RE: REPLY COMMENTS
DISTRIBUTION SYSTEM/HOSTING CAPACITY STUDY
DOCKET NO. E002/M-18-684

IN THE MATTER OF THE XCEL ENERGY
2018 HOSTING CAPACITY REPORT UNDER
MINN. STAT. § 216B.2425, SUBD. 8

DOCKET NO. E002/M-18-684

REPLY COMMENTS

Figure 1: Xcel Energy DER Interconnection Tools and Processes

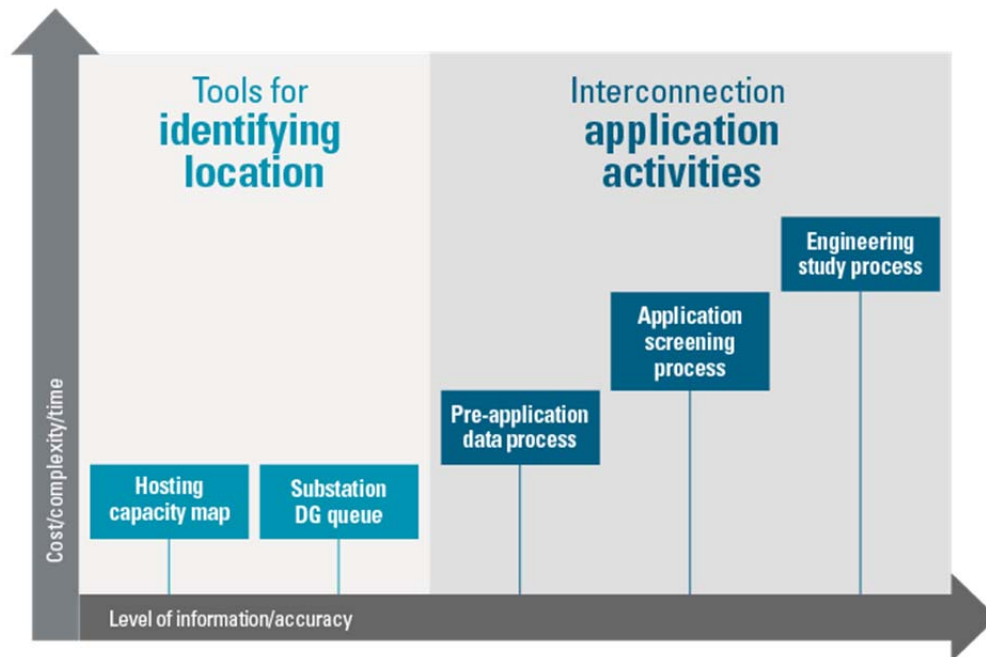
For example, the accuracy expectations for the HCA contained in Fresh Energy’s Comments are that it match the results from the pre-application data report (“capacity screens” for Solar Gardens). The pre-application data report simply provides existing system data; this is not an analysis, and does not offer capacity “results” per se, but instead provides an up-to-date snapshot of system information. It is unclear which pre-application data number is being considered the “result” by Fresh Energy.¹¹ In contrast, hosting capacity does run some preliminary analysis and provide an estimate of available capacity at a particular location. The tools are complementary and should not be viewed as interchangeable.

Figure 1 below shows how the different pieces of interconnection processing

currently work. The lower cost and complexity¹² options of hosting capacity and pre-application data provide information Developers can use to target points on the distribution system for interconnection prior to submitting an application. The screening and study processes occur after an application has been submitted and entered into engineering review.

The hosting capacity map display is a high level estimate of the available hosting capacity for adding DER in a given general location. The determination of the amount of DER that can be accommodated at a point in the distribution system can include several steps, with more specific and more accurate information becoming available as the effort and expense to provide that more specific information increases.
